Planning Service
London Borough of Haringey
L6 River Park House
225 High Road
Wood Green
N22 8HQ

Planning Application HGY/2024/0921 Erection of one additional storey at roof level to existing building to provide two self contained apartments, plant and associated works

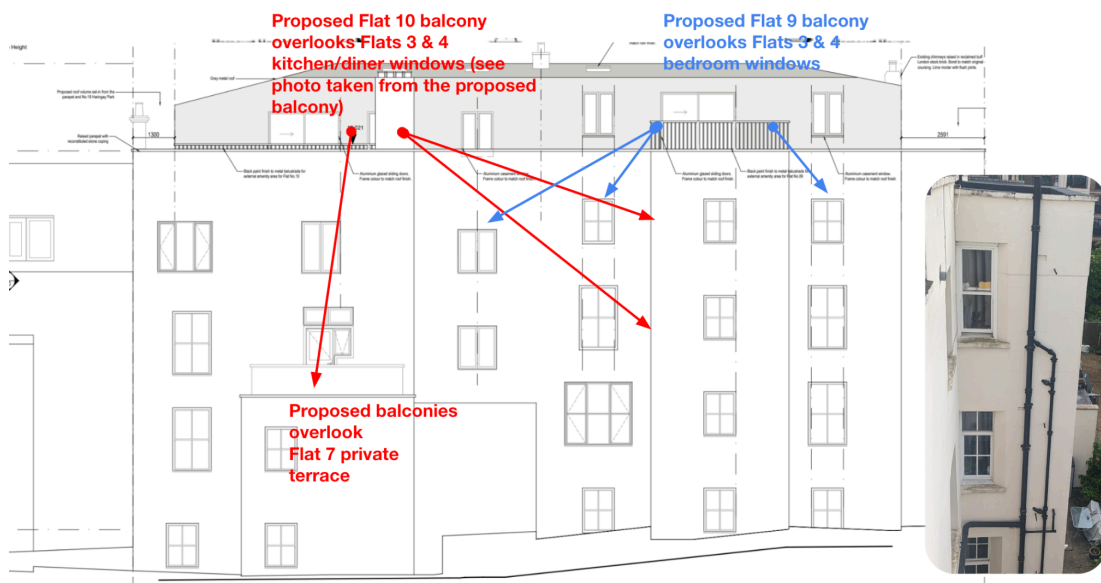
- 2.3. The proposed extension is asymmetrical, clad in metal and has metal windows. All are neither typical nor traditional and will not complement the existing host building, which has

Victorian proportioned traditional timber framed windows throughout. This will create dissonance and cause harm to the overall appearance of the conservation area.

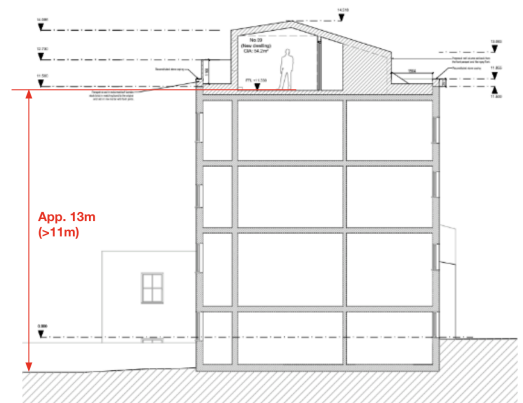
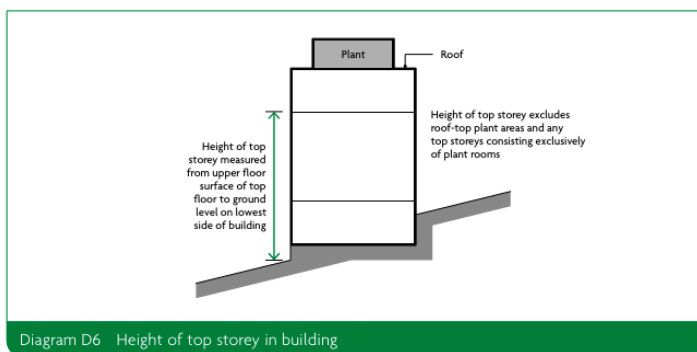
- 5.1. The proposed section (drawing CF-214-DR-1210-A) inaccurately depicts the new extension resting directly on the existing timber roof. This representation is misleading and very likely unbuildable, as the existing roof is designed for snow loading only. Structural support for the proposed extension would necessitate steel beams (approximately 400mm deep, as advised by our structural engineer's calculations²). Additionally, floor voids are required to accommodate drainage for the new bathrooms and kitchens, as they are not aligned with existing drainage stacks. The applicant must either demonstrate how these structural and drainage issues will be addressed within the proposed extremely shallow floor build-up or revise the section and other drawings/visuals to accurately reflect the actual structure and

service zones. This will ensure a genuine assessment of the roof extension's visual impact can be made, and the application will not require further material amendments that are almost certain at this stage.

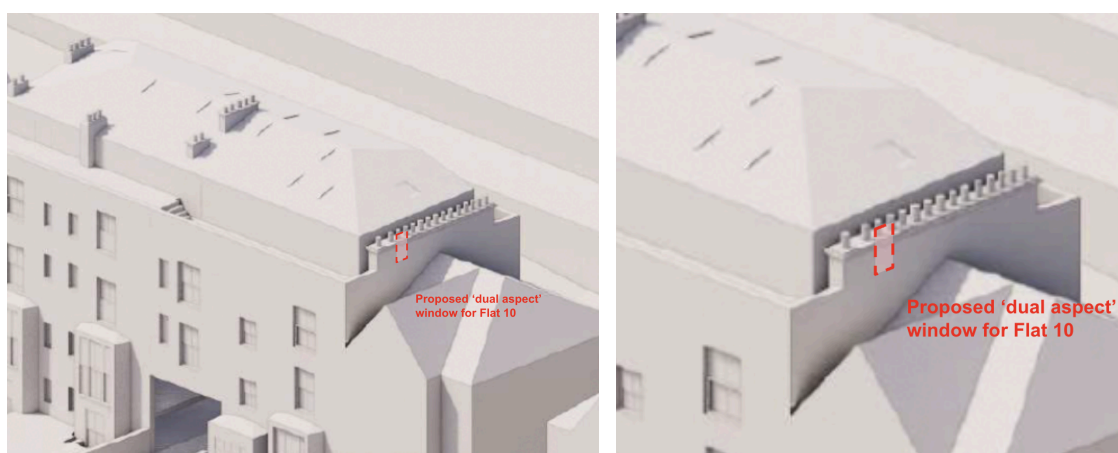
- 6.1. The proposed development, in its current form, fails to comply with several Building Regulations. These non-compliances necessitate alterations to the layout and appearance of the proposal which are planning matters.
- 6.2. The extended building will be >11m and >4 stories (see diagrams below) and will trigger the need for 'building-wide' changes to meet the new Building Safety Act. Sprinklers, smoke vents and protected fire lobbies will be required to meet the latest Building Regulations AD Part B.

- 6.4. As confirmed in the applicant's Design and Access Statement and Heritage Statement, Harcourt House was already extended from 2 Victorian villas in the 1920s. A significant portion of the building continues to rest on the original Victorian foundations, yet the applicant has not provided details on how the existing structure will accommodate the proposed further extension. This omission is a significant planning matter, as excavation and underpinning will likely be necessary to reinforce the existing Victorian foundations to support the proposed development. Furthermore, due to the constraints of working within a building containing occupied flats, additional external structures may be required to bolster the external masonry walls during construction. To address these concerns, the applicant must submit a comprehensive structural report detailing how they intend to support the roof extension while utilising the existing Victorian structures. This report should thoroughly assess and outline methodology and visual impact, as well as potential disruptions to existing residents and neighbouring properties. This will ensure that the full impact of the proposed development can be properly understood and evaluated.
